## 219 1ST AVE N

DPD PROJECT #3016745

12.17.2014 Design Review Recommendation Meeting 6:30 pm at Queen Anne Community Center  
219 1ST AVE N | MIXED USE APARTMENT BUILDING | DPD PROJECT # 3016745

RESPONSE TO CYCLE 1 MUP CORRECTIONS

MASSING RESPONSE

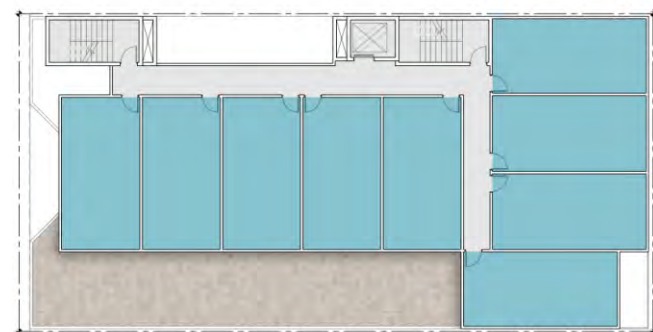
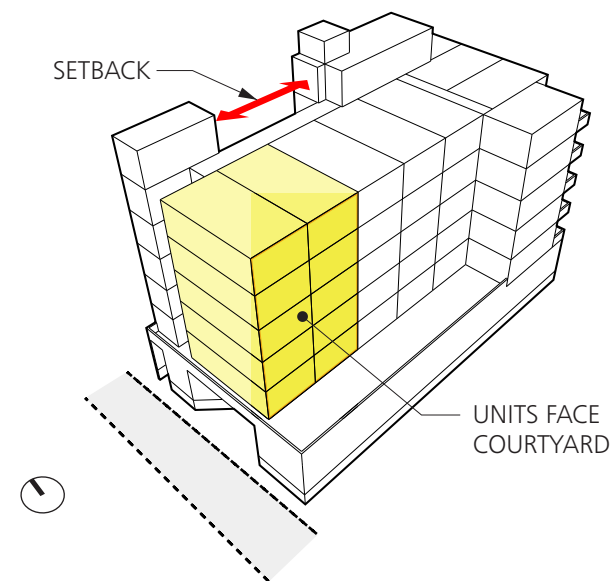
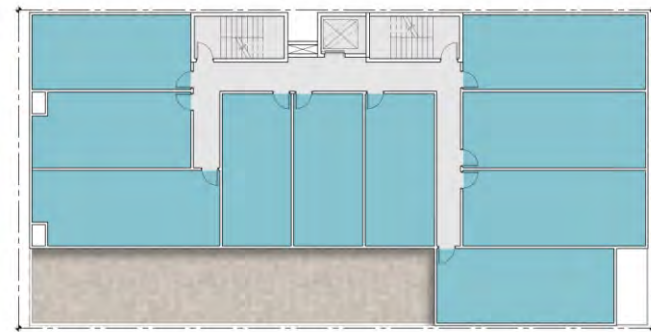
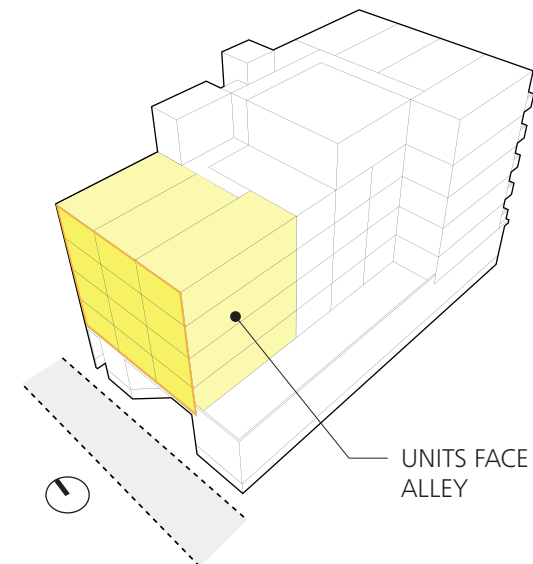
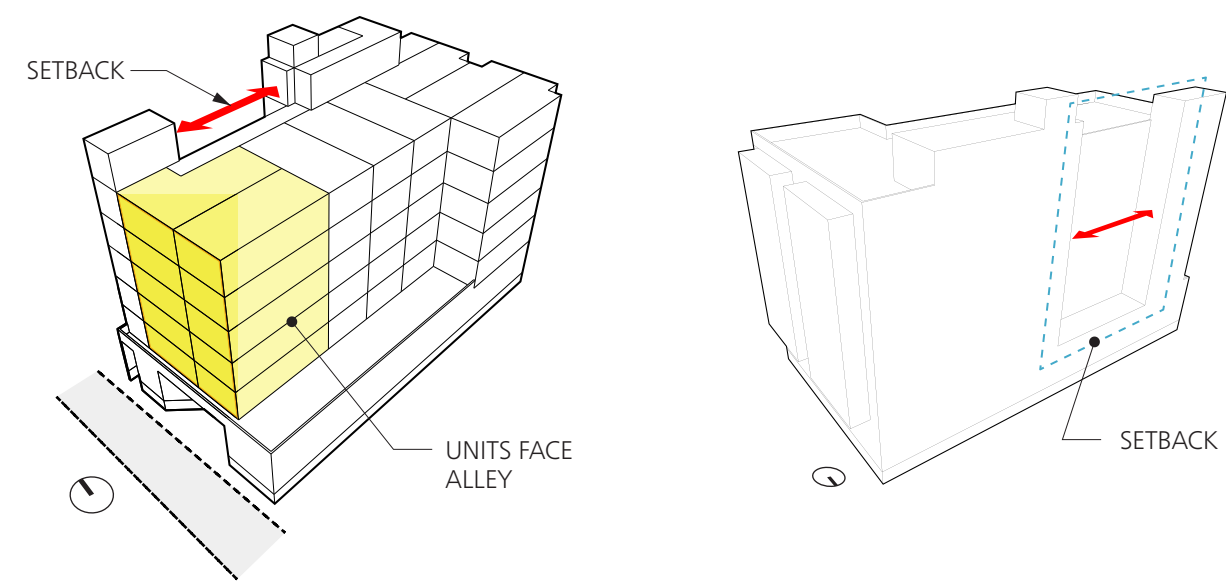
EDG RECOMMENDATION	RESPONSE
MASSING	
<p>The Board felt Massing Option A provided the better design solution with a setback along the north facade opposite the existing units. The Board also supported the unit orientation of Massing Option B, which provides units facing the alley.</p> <p>a) The Board felt the applicant provided a comprehensive analysis of the massing options for a tight infill site. The Board supported the building layout with the lobby and stair circulation on the north and units oriented to the south. (CS2-D5)</p> <p>b) Ultimately the Board supported a massing option combining A and B. The combined massing should include a setback on the north facade consistent with massing option A and units facing the alley consistent with Massing Option B. The Board did support a taller building, consistent with Massing Option A, to accommodate the additional north setback (CS2-D5, DC2-A1).</p> <p>c) The Board agreed there must be a thoughtful treatment of the facade facing the structure to the north. At the Recommendation Meeting, the Board would like to see how the north facade is treated to minimize large expanses of blank wall and maximize light and air opportunities for adjacent units (CS2-D5, DC2-B2).</p>	<p>a) The proposed building layout locates the stairs, elevator and lobby towards the north with the residential units facing the street (east), alley (west) and south thus respecting the privacy of residents in the proposed building as well as the adjacent apartment building to the north. (CS2-D5 - Respect for Adjacent Sites)</p> <p>b) The proposal has been revised to provide a setback to the north consistent with massing option A and unit orientation facing the alley consistent with massing option B. (CS2-D5 - Respect for Adjacent Sites, DC2-A1 - Massing - Site characteristics and uses). The setback provides more light and ventilation for residential units in the apartment building to the north. Orientation of the units towards the alley guarantees light and ventilation for residents. The L-shaped massing maximizes light and ventilation for the proposed residential units facing the south side lot line.</p> <p>c) The north facade has been divided into three segments instead of one linear, expansive long facade. (CS2-D5 - Respect for Adjacent Sites, DC2-B2 - Architectural Facade and Composition - Blank Walls) Each segment has been treated with variation in color and material joint patterns, thus creating visual interest and reducing the scale of the building. A setback and an exterior open stair has been included on the north side to maximize light and air for units in the adjacent apartment building. See additional comments on MUP response page (p.16) .</p>

The DRB massing responds to the Board's recommendation by orienting the rear units to face the alley (similar to option A) while maintaining a larger setback on the north side (similar to option B).

NORTH FACADE

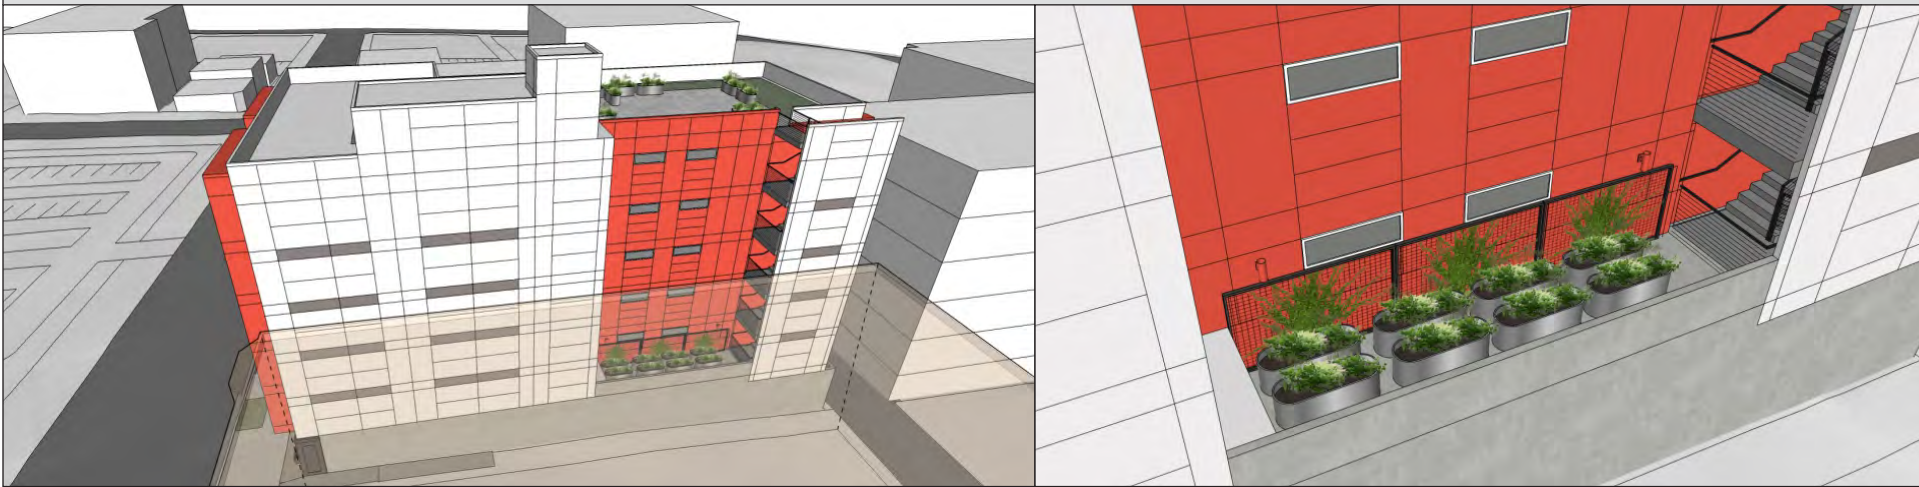
CORRECTIONS	RESPONSE
NORTH FACADE	
<p>At EDG the Board agreed there must be a thoughtful treatment of the façade facing the structure to the north. At the Recommendation Meeting, the Board would like to see how the north façade is treated to minimize large expanses of blank wall and maximize light and air opportunities for adjacent units (CS2-D5, DC2-B2).</p> <p>Please consider incorporating windows, or obscured glazing into the facade facing north setback to mitigate the large blank wall facing adjacent residential units.</p>	<p>Please refer to vignettes on pages 17, 26, 35, and 42 showing the treatment of the north facade.</p> <p>Windows have been incorporated into the facade facing the north setback. The north facade has been divided into three segments instead of one linear, expansive long facade. (CS2-D5 - Respect for Adjacent Sites, DC2-B2 - Architectural Facade and Composition - Blank Walls) Each segment has been treated with variation in color and material joint patterns, thus creating visual interest and reducing the scale of the building. A setback and an exterior open stair has been included on the north side to maximize light and air for units in the adjacent apartment building. Planters and green screens have also been included in the north courtyard to enhance views from the adjacent apartment building.</p>

GROUND FLOOR COMMERCIAL

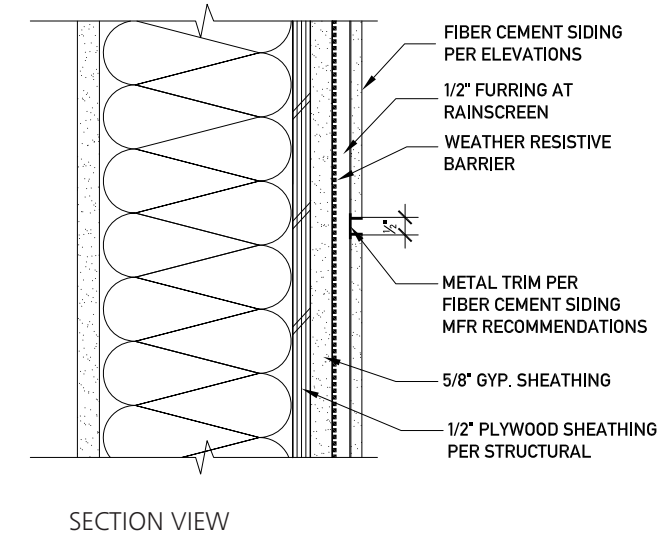
GROUND FLOOR COMMERCIAL	
<p>At EDG the Board noted the setback should be treated to provide a gracious, welcoming approach to the retail and residential entrances (CS2-A2, CS2-B2, CS2-C2). At the Recommendation Meeting, the Board requested more information about the experience at ground level including ground level transparency, overhead weather projection and lighting. The Board also felt the applicant should explore additional potted landscaping at the residential entry as expressed in the Uptown Design Guidelines. The Board felt the entries should be pedestrian scaled, friendly, gracious, and incorporate sufficient transparency and lighting to provide safe spaces (PL2-B, PL2-C, PL3-A)</p> <p>Please provide a draft recommendation packet demonstrating through ground level elevations and vignettes the experience of the ground level commercial space.</p>	<p>The experience of the ground level space has been shown. Please refer to vignettes on pages 17, 26-29, 31, 40, and 42.</p> <p>The setback at ground level provides a wider, inviting sidewalk with landscaping. This setback continues a strong street edge aligning with the ground level of the apartment building to the north and creates a distinct ground floor facade similar to other buildings in the immediate vicinity of the site. (CS2-A2 - Location in the City and Neighborhood - Architectural Presence, CS2-B2 - Adjacent Sites, Streets and Open Spaces - Connection to the Street, CS2-C2 - Relationship to the Block - Mid block Sites)</p> <p>The ground level minimizes blank wall segments and maximizes light and transparency through the use of wide storefront glazing. The bay window projections of the upper floors provide ample overhead weather protection for the building entrances. Ground level exterior lighting has been incorporated on the ground level exterior walls and on the soffit of the bay window projections. Potted plants have been incorporated at the residential entry. Additionally, a change in the sidewalk scoring pattern at the residential entrance further accentuates the transition from public to private space. The proportion/division of the street front glazing, signage and overhead bay window projections provide a more human scale at the sidewalk. All of the above encourage safety, security, visibility and provide a comfortable pedestrian experience. (PL2-B - Safety and Security, PL2-C - Weather Protection, PL3-A - Entries)</p>

BAY WINDOWS

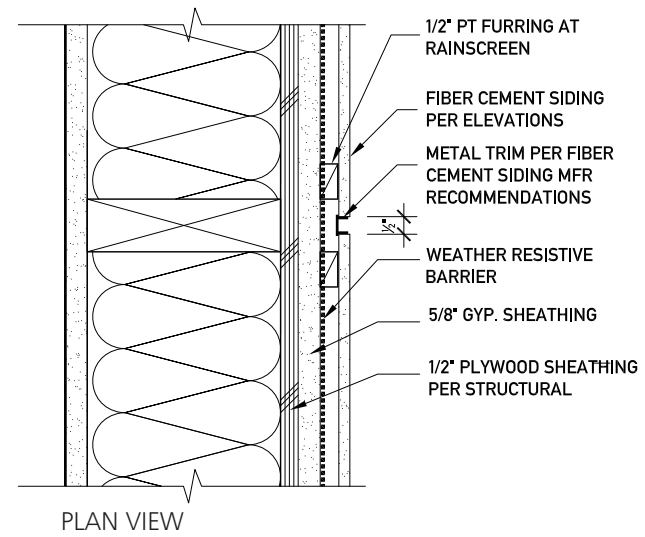
BAY WINDOWS	
<p>The Board felt the first floor level transition to the upper level should align with the bay window datum to the north (CS2-C2).</p> <p>The Board was concerned that the adjacent bay window will look into a large blank wall in the northeast corner. The Board felt the building should respond to this relationship and treat the corner with a meaningful gesture to provide relief (CS2-C2. CS2-D5).</p> <p>Please demonstrate in plan, elevation and section how the proposed building responds to guidance to respond architecturally to adjacent bay windows.</p>	<p>The relationship to the adjacent building's bay windows has been shown. Please refer to vignettes on pages 17, 26-27, 40, and 42</p> <p>It is not feasible to align the first floor transition to the upper level with the bay window datum to the north since the grade drops down towards the south on the street. Moreover, the adjacent apartment building has a basement that is partially above grade which makes its floor lines fall approximately midway (half a story) between the floor levels in the proposed building.</p> <p>The north bay window in the proposed building is set back 4 feet from the north edge of the building to create more room at the northeast corner for the bay windows in the apartment building to the north. Moreover, the south facing window in the bay window projection of the adjacent building has a diagonal orientation looking southeast rather than directly south toward the proposed building.</p> <p>(CS2-C2 - Relationship to the Block - Mid block Sites, CS2-D5 - Height, Bulk and Scale - Respect for Adjacent Sites)</p>

CEMENT PANELS / SOUTH FACING BLANK WALLS

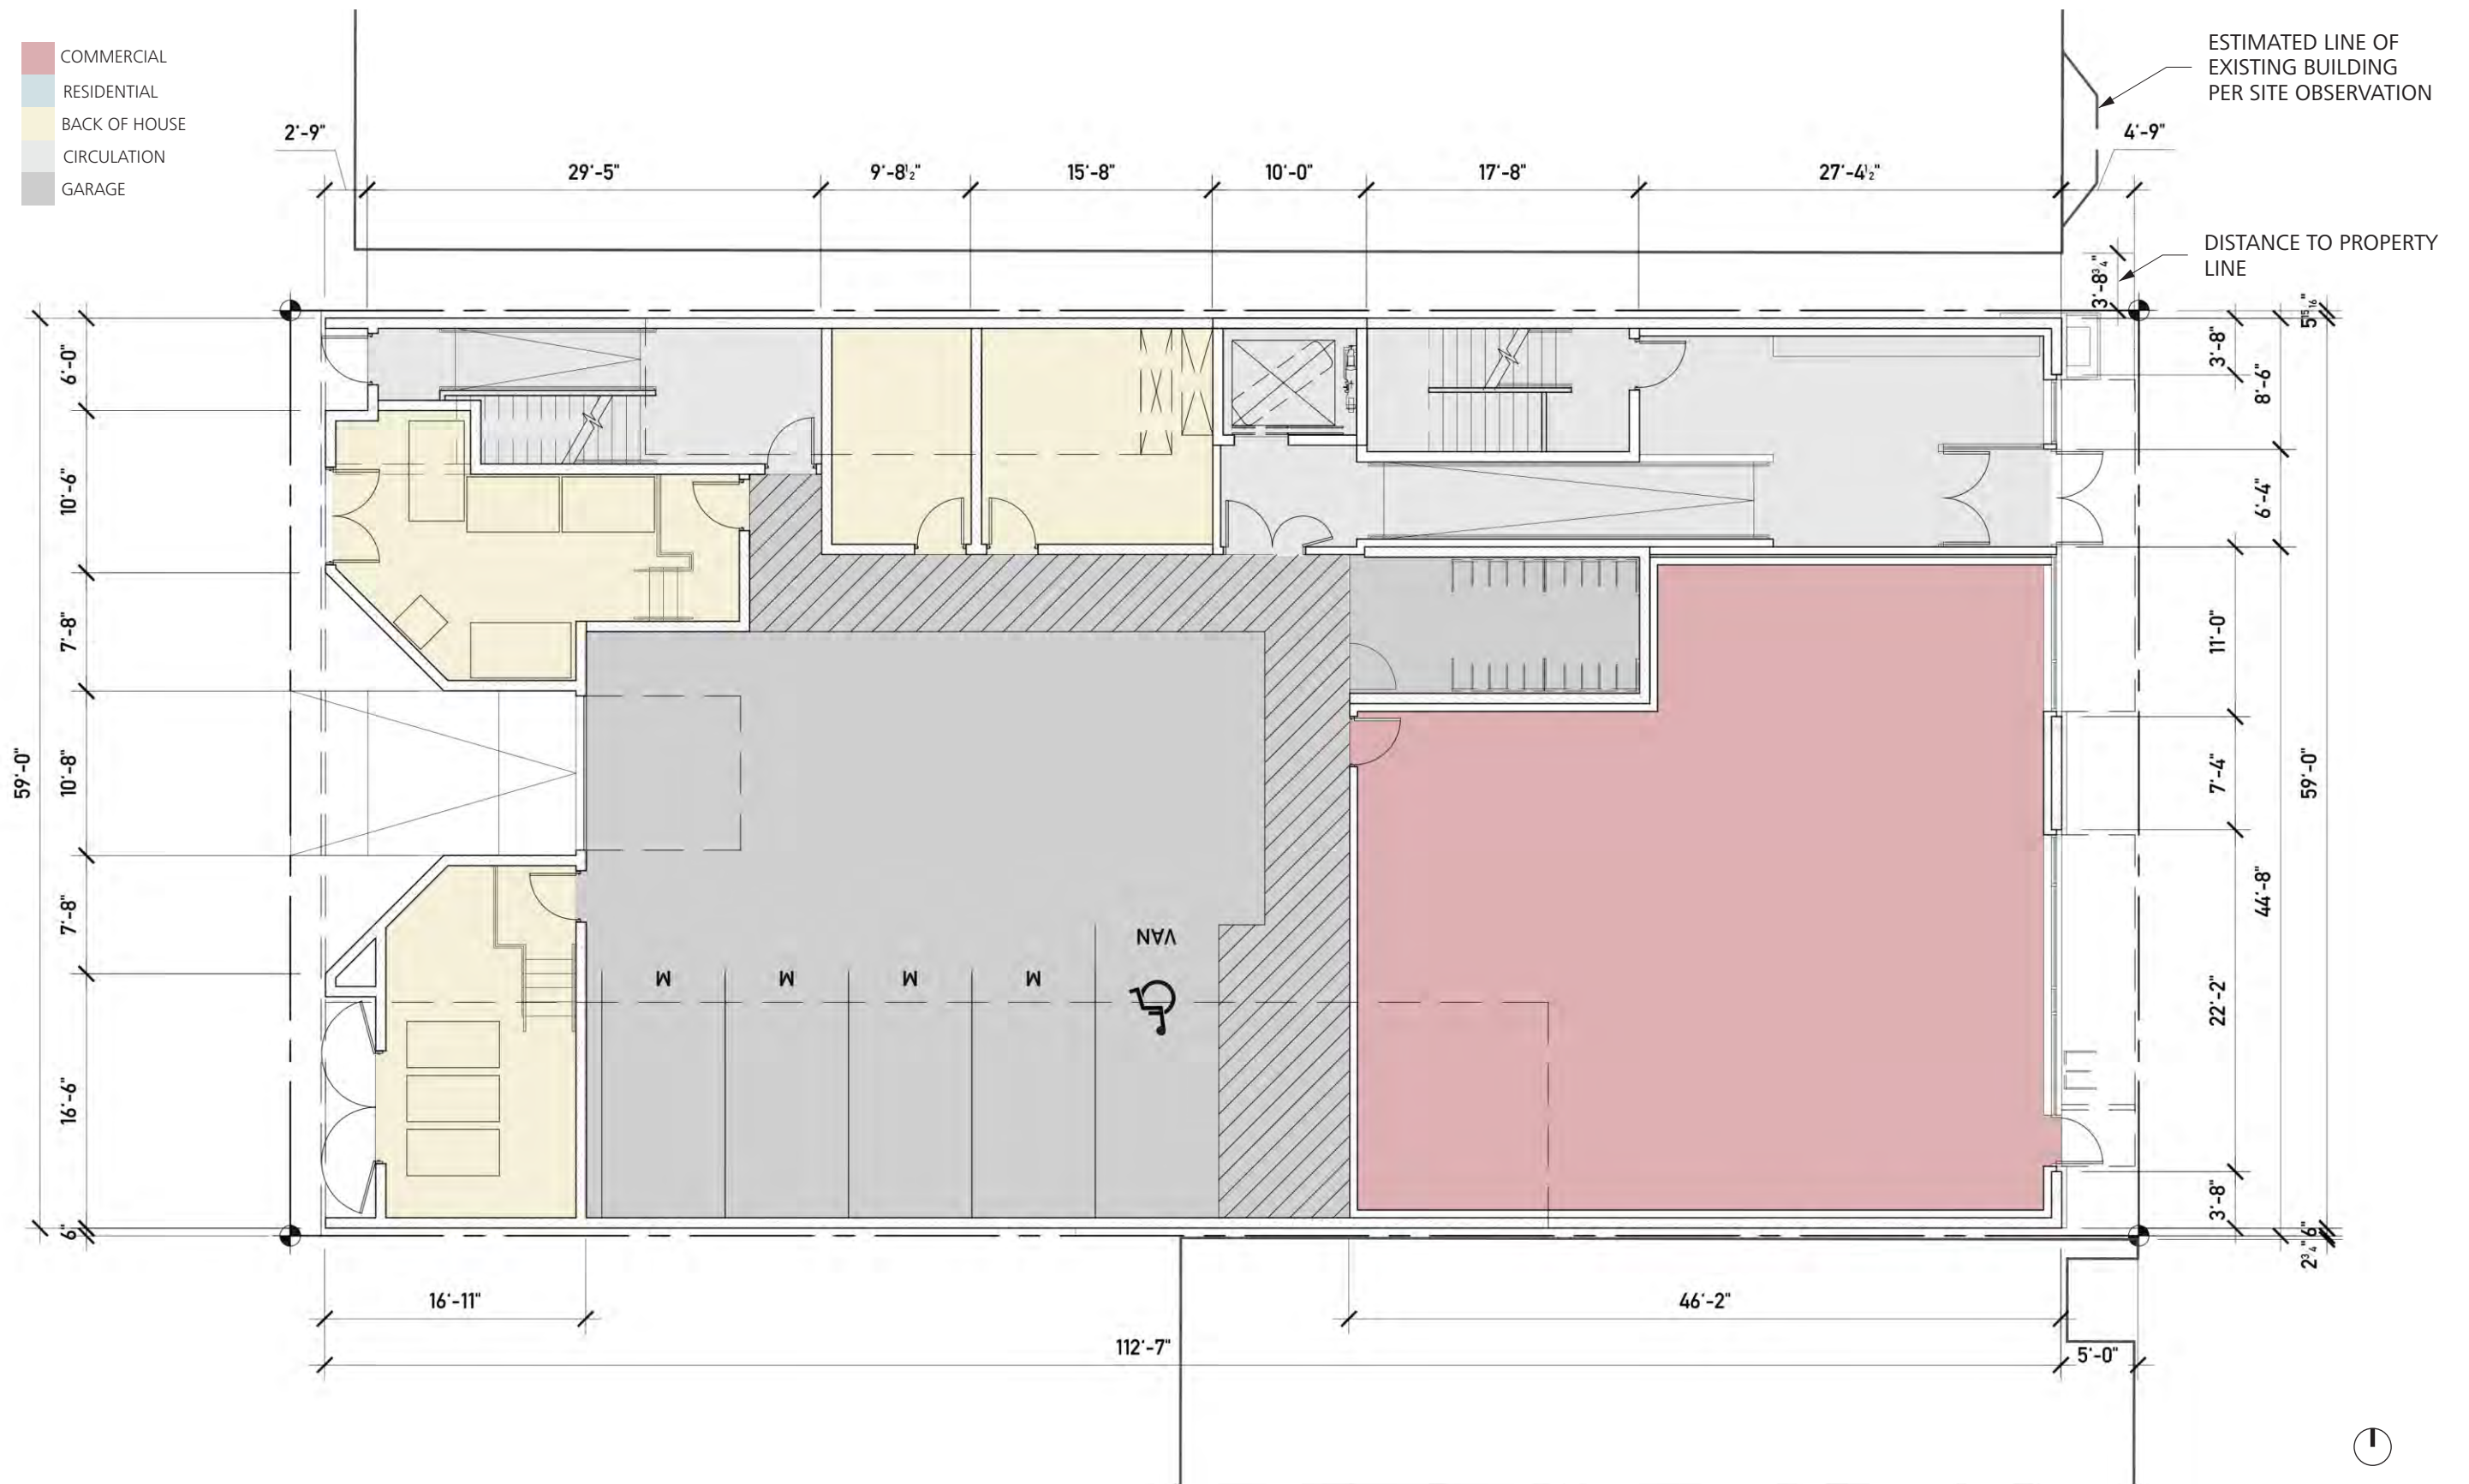
CEMENT PANELS / SOUTH FACING BLANK WALL	
<p>Please clarify within the MUP plans and recommendation packet the details of the cement panel application. Will there be visible reveal and reglets or integrated rain screen? Currently there is a large blank wall that will be largely visible from 1st Avenue S traveling in the north bound direction. Please consider ways this large wall can be linked to the articulation on the other facades. Please consider further articulation such as double width reveals and/or offset panel depth to create small shadow lines. Small changes in panel depth will further the concept of street bays transitioned onto the side achieving a purposeful transition in color rather than an in plane material change.</p>	<p>The detail of the cement panel application has been included. Please refer to details on page 17 . Please also refer to vignettes on pages 17, 30, 33, 41, and 43.</p> <p>At this point, variation in color and joint patterns has been provided on the south wall. It is not feasible to implement further articulation on the south wall with changes on panel depth and/or change in material without obtaining a temporary construction access agreement with the adjacent property owner to the south. Without this agreement, the only method to build this wall is to balloon frame and tilt up into position, with siding and waterproofing already attached. Because of the weight and constructability of the assembly, single material use with variation in color and joint patterns is the only option to provide some interest on this façade. An attempt will be made to reach out to the adjacent property owner for a temporary construction access agreement so that further articulation may be provided.</p>
